# 6633B-09 <u>S E R V I C E N O T E</u>

## Agilent 6633B DC Power Module

There is a possible glitch on the output due to an AC Line sag between 23 VAC to 27 VAC.

Figure 1. A1 Board Layout

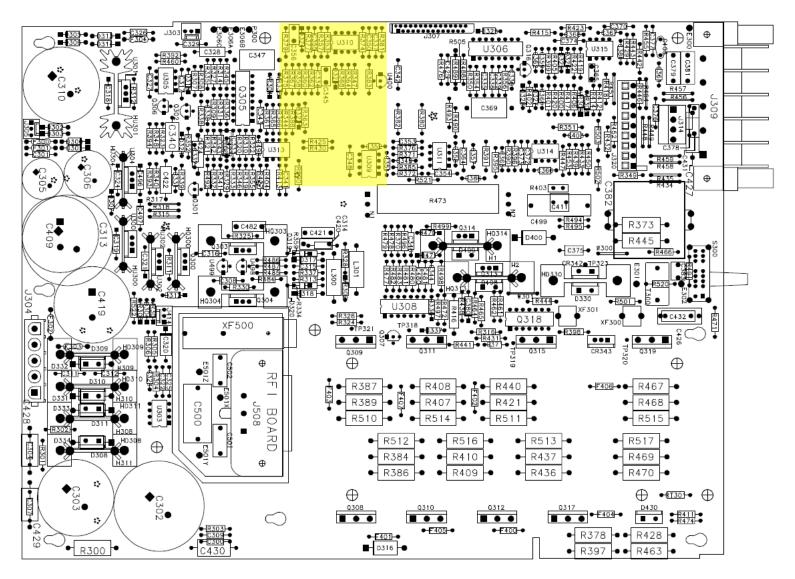
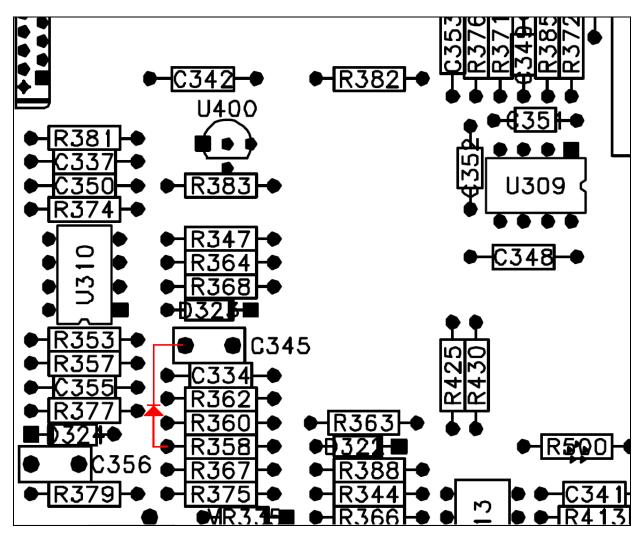
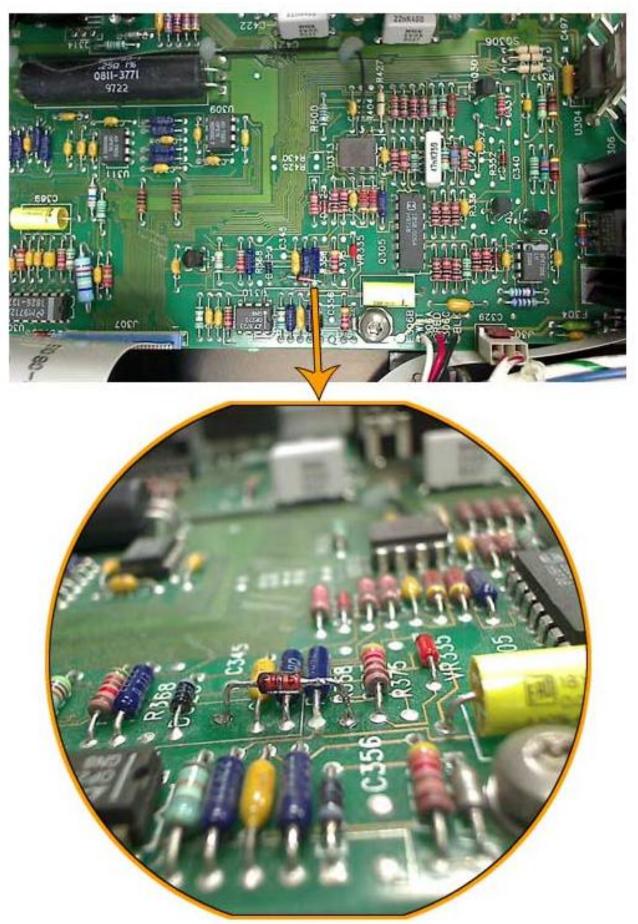
There is a possible glitch on the output due to an AC line sag between 23 VAC to 27 VAC. The time length of the glitch pulse is about 1.9s and the power supplied is 2.8W.

It is caused by a condition in which the current offset and voltage offset DACs do not reset, when the current and voltage programming DACs reset during an AC line sag. This results in an op-amp that normally operates at -5V DC to operate in the positive direction, and drives the output of the 6633B on.

The solution is to implement a diode (P/N 1901-1344) that clamps the op-amp to 0.7 V. This prevents the op-amp from driving the output on, and does not affect it due to a normal operation at -5V DC.

The figures below show where to solder the diode (P/N 1901-1344) from R358 to C345 on the A1 main board.
